Enclosure 2 to the Letter from C. W. Giesler
to H. R. Denton
Dated November 30, 1984

Proposed Amendment 64 to the KNPP Technical Specifications
Affected Pages

3.1 CONTROL ROD AND POWER DISTRIBUTION LIMITS.

FIGURE TS 3.10-2 HOT CHANNEL FACTOR
NORMALIZED OPERATING ENVELOPE

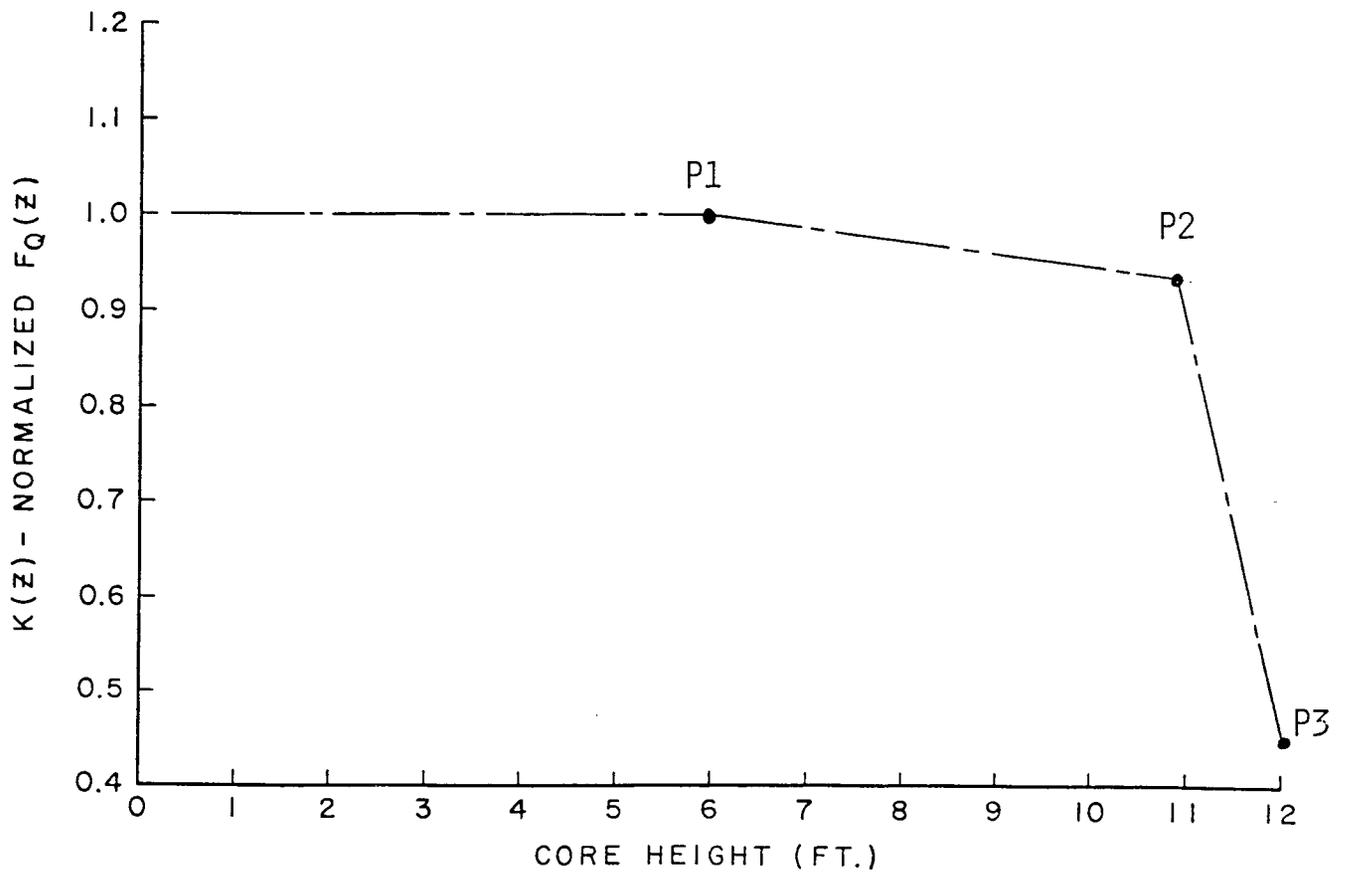
K(Z) is the function given in Figure TS 3.10-2

Westinghouse Fuel K(z) Coordinates	Exxon Nuclear Fuel K(z) Coordinates
P1 (6,1.0)	P1 (6, 1.0)
P2 (10.99, 0.932)	P2 (10.84, 0.938)
P3 (12, 0.467)	P3 (12, 0.438)
Normalized to 2.14	Normalized to 2.28

Figure 3.10-6

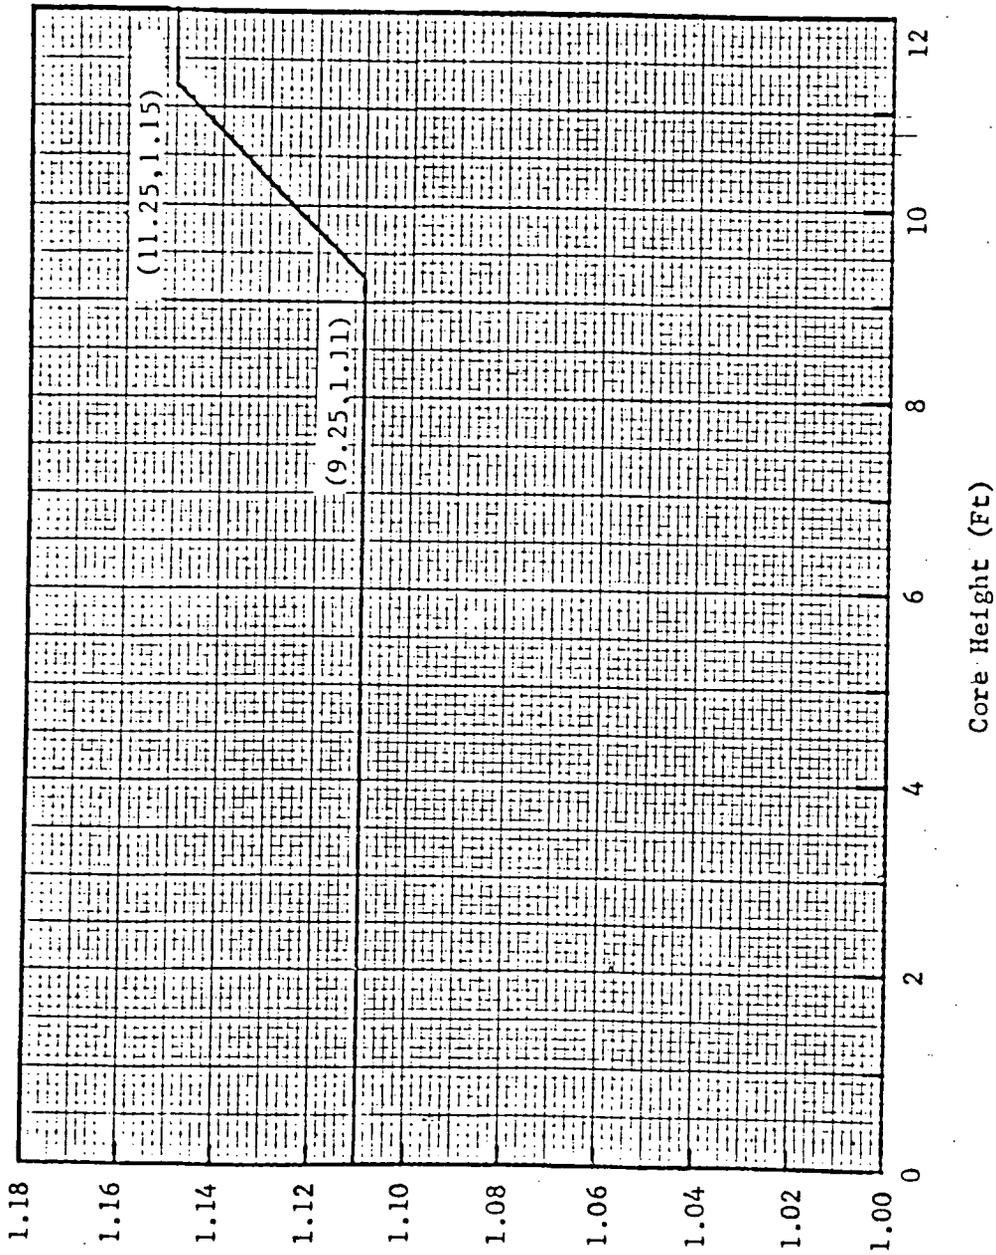
V(Z) is defined in Figure TS 3.10-6.
